6748B County Permit Review Worksheet

IMPROVEMENT PERMIT for a RESIDENTIAL ON-SITE WASTEWATER TREATMENT & DISPOSAL SYSTEM

RE: Request for an Improvement Permit for Lot 10 off of Sample Road.
MCHD File #6748B

SEPTIC SYSTEM DESIGN REVIEW WORKSHEET

Sketch of Soil Evaluation Locations

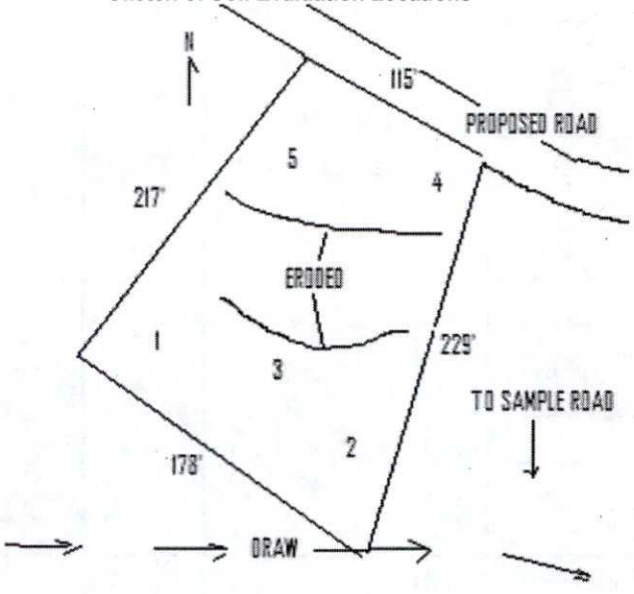
1. Need to get revised application indicating 5 bedroom house (600 GPD).
2. Need to revise soil report to show evaluation for a 5 bedroom house (600 GPD).

Owner: Faison-Sample Road, LLC
Applicant: Toney Jacobs
Address: 121 W.Trade St., 27th Floor, Charlotte, NC 28202-5399
Date Evaluated: 1/3/2007
Proposed Facility: Residence
Design Flow (.1949): ~~480 gpd~~ 600
Property Size:
Location of Site: Sample Road
Property Recorded:
Water Supply: [x] Public [ ] Individual [ ] Well [ ] Spring [ ] Other
Evaluation Method: [x] Auger Boring [ ] Pit [ ] Cut
Type of Wastewater: [x] Sewage [ ] Industrial Process [ ] Mixed
